2002 Ford Mustang GT V8-4.6L SOHC VIN X

ENGINE - OIL LEAK FROM R/H CYLINDER HEAD GASKET

03-6-2

ENGINE - CYLINDER HEAD DECK LEAK - 4.6 AND
5.4L ENGINES - NEW "SERVICE-ONLY" GASKET AND
CYLINDER HEAD KITS AVAILABILITY

Figure 1

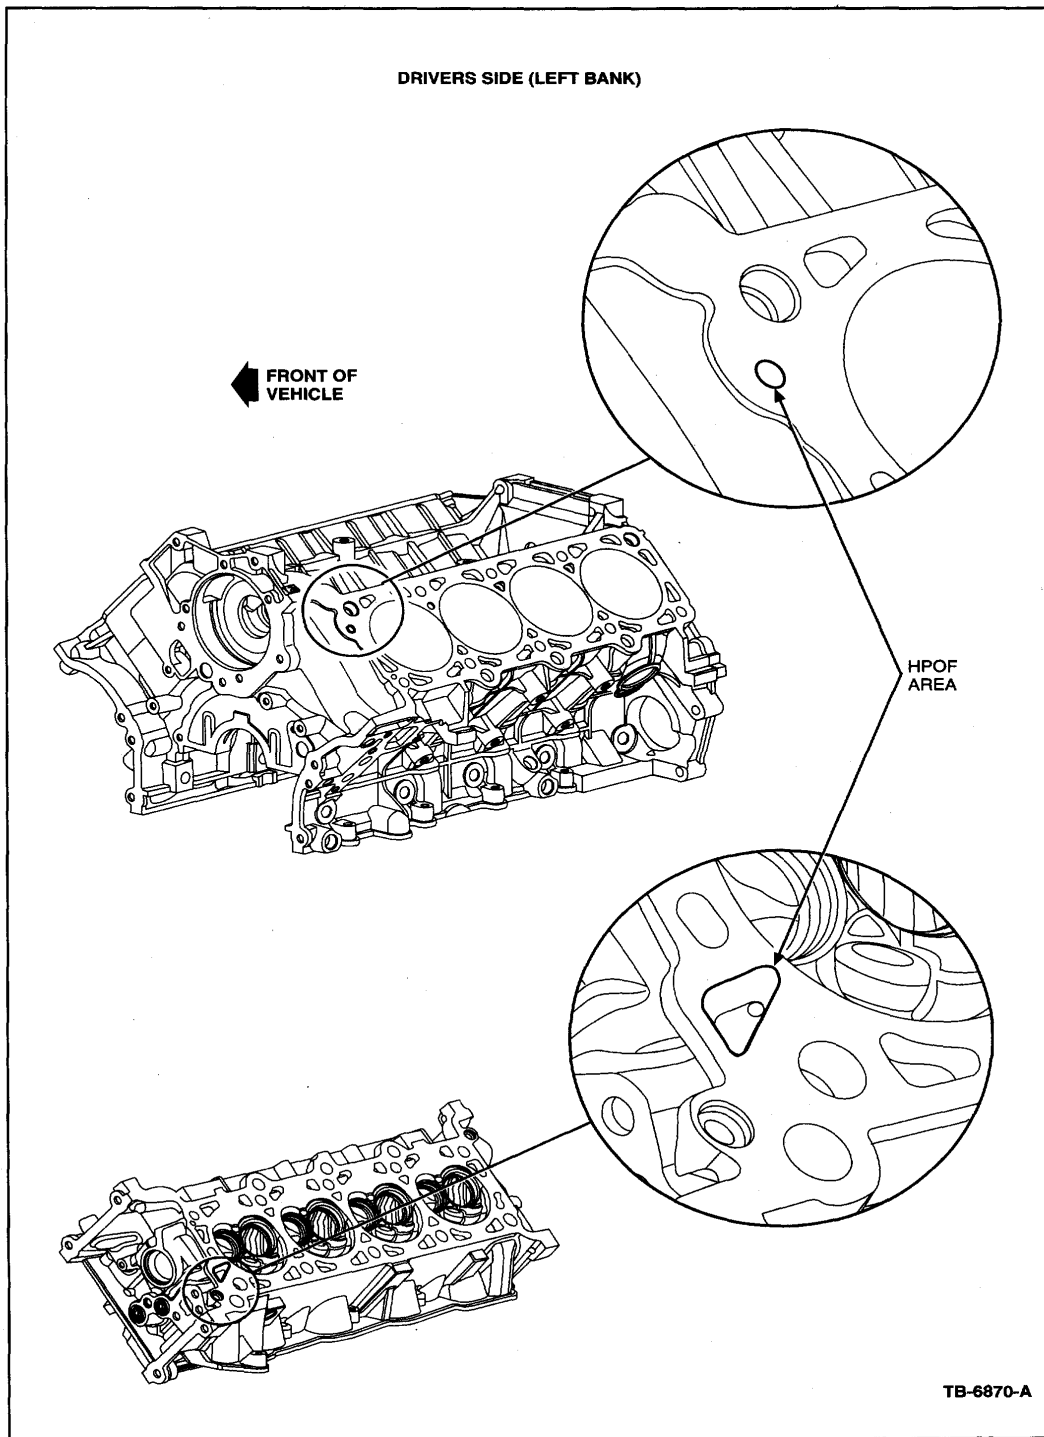
Cylinder heads damaged by brinnelling (depression marks from original gasket) of the head may still be reusable. The revised "Service-Only" gasket has a feature by which the embossed sealing area does not follow the same sealing path as the original gasket. This area is surrounding the High Pressure Oil Feed (HPOF) area. It is triangular in shape and is found in the rear of the passenger side cylinder head, or, in the front of the drivers side cylinder head (Figure 1 and Figure 2).

^ Service-only gasket (3U7Z-6051-BA for drivers side and/or 3U7Z-6051-AA for passenger side) with the new embossed area
